"MOVABLE LOADING BRIDGE HAVING
AN INFLATABLE FLEXIBLE BODY"

REVISED RESPONSE TO OFFICE ACTION

LETTER SUBMITTING PROPOSED DRAWING CHANGES

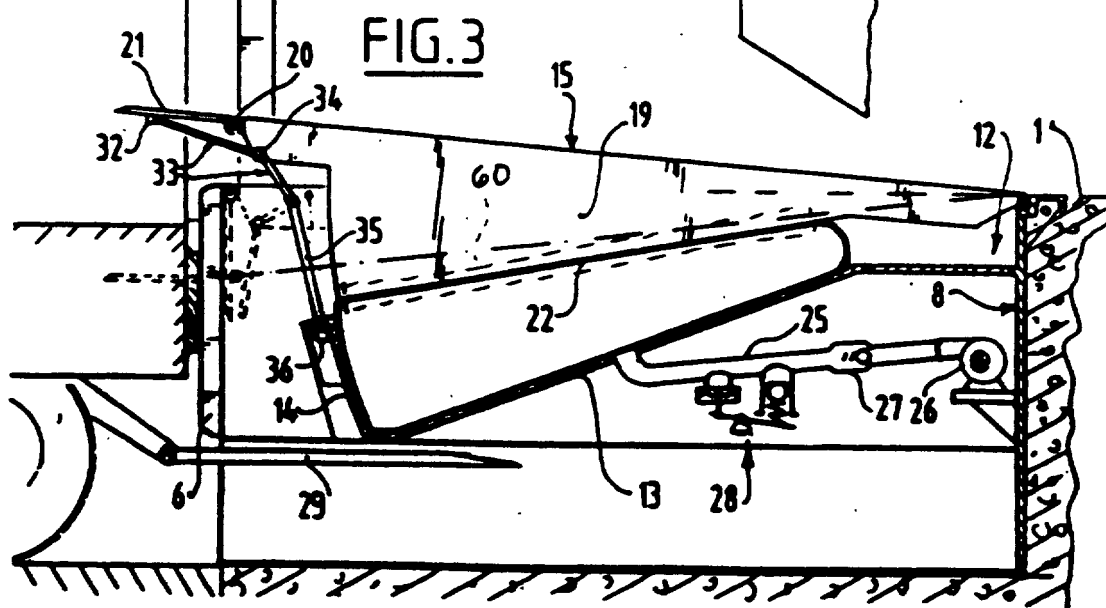
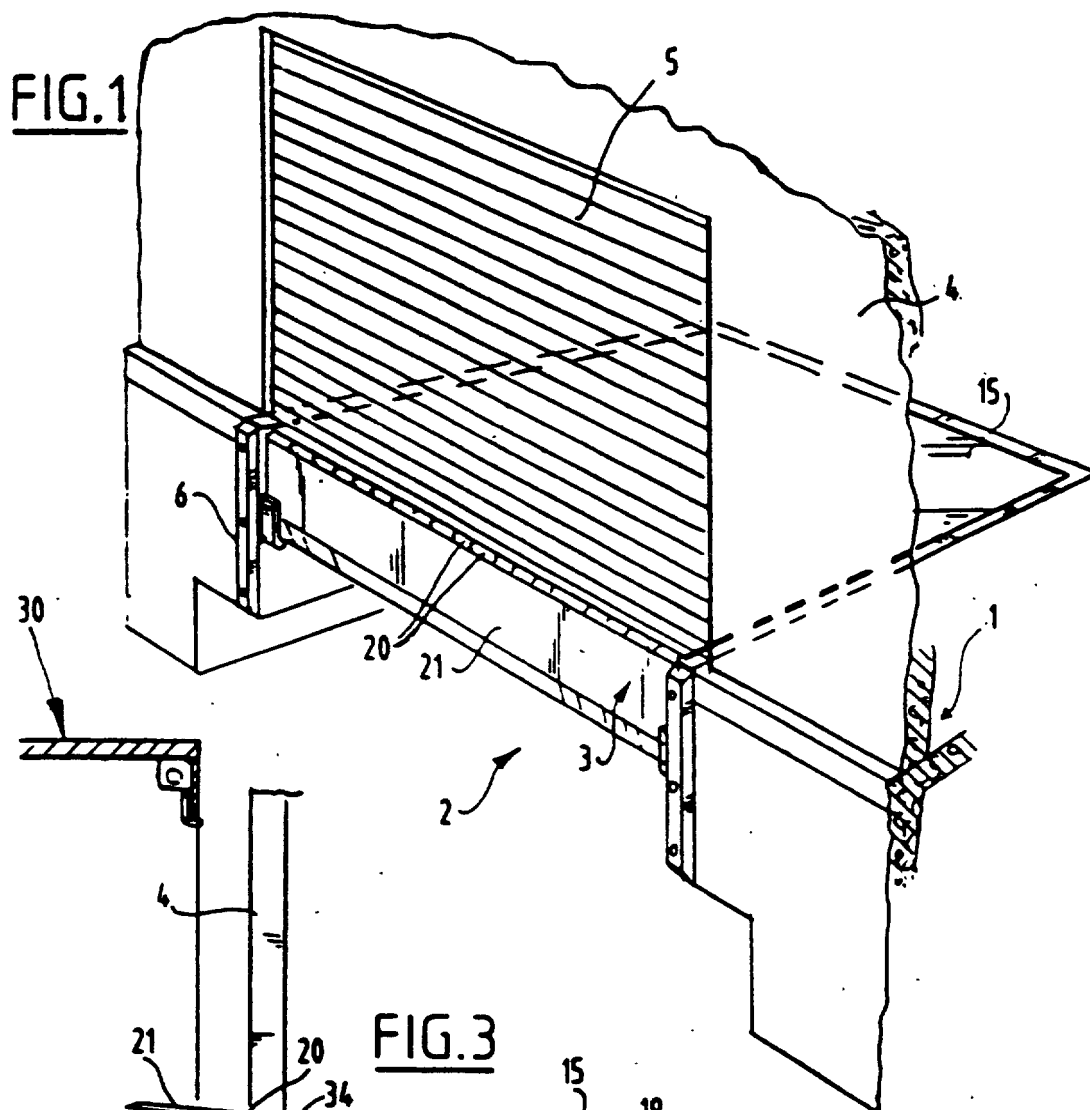
The drawings are objected to under 37 CFR §1.83(a) on the grounds that they do not show the claimed buttons of claim 21. To correct the problem, Applicant submits herewith a copy of a Letter Submitting Proposed Drawing Changes, which seeks to amend Figs. 2 and 3 to schematically illustrate the flexible body "buttoned" to the planar member, as shown in red ink on the enclosed drawings. The original Letter Submitting Proposed Drawing Changes was filed with Applicant's Response filed June 18, 1996). Further, Applicant has amended the specification to include a reference numeral for the buttons. No new matter has been added. The proposed changes to the drawings merely add subject matter already described in the Specification at column 2 lines 57-59. Entry of this amendment to the drawings and withdrawal of the objection are respectfully requested.

Applicant proposes amendment of Fig. 3 of the drawings as indicated in red ink on the attached sheet.

The changes to the drawings are in response to the Examiner's objection to the drawings set forth in the Office Action dated March 5, 1996. These changes add a schematic representation of the buttons described in the specification at column 2, lines 57-59, along with a corresponding reference numeral "60".
